TANDBERG TAPE RECORDER INFORMATION

No. 104
Oslo, 2nd December 1970

Series 3000X/6000X

Modified take-up clutch

Bottom view of take-up turntable and friction disc.

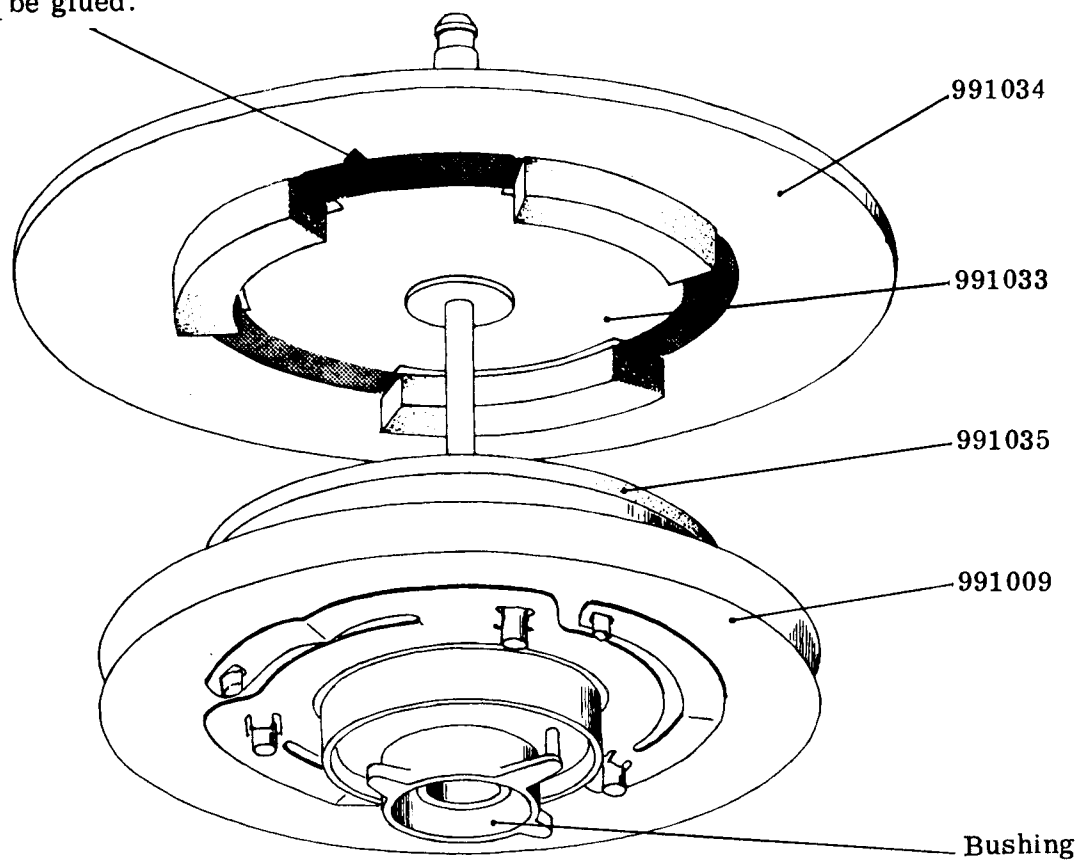
The materials originally used in the take-up clutch have after prolonged operation in hot environments in some cases shown a tendency of excessive wear.

Clutch components in a better material were introduced in production from the following serial numbers:

In some units, the bushing in the friction disc has a wide flap instead of a small stud to prevent rotation. The bushing with the flap can be snapped out of the bearing by means of a screwdriver and must be installed in the new friction disc to facilitate the rest of the assembly

The hatched areas indicate the adhesive coating holding the friction pads. The mylar sheet must not be glued.

1 ea take-up turntable with friction pads, and mylar sheet with felt part No. 991034

1 ea take-up friction disc with coupling disc, spring, ball bearing and bushing part No. 991009

Take-up turntable	part No. 991034
Mylar sheet	part No. 991033
Coupling disc with felt	part No. 991035
Take-up friction disc	part No. 991009
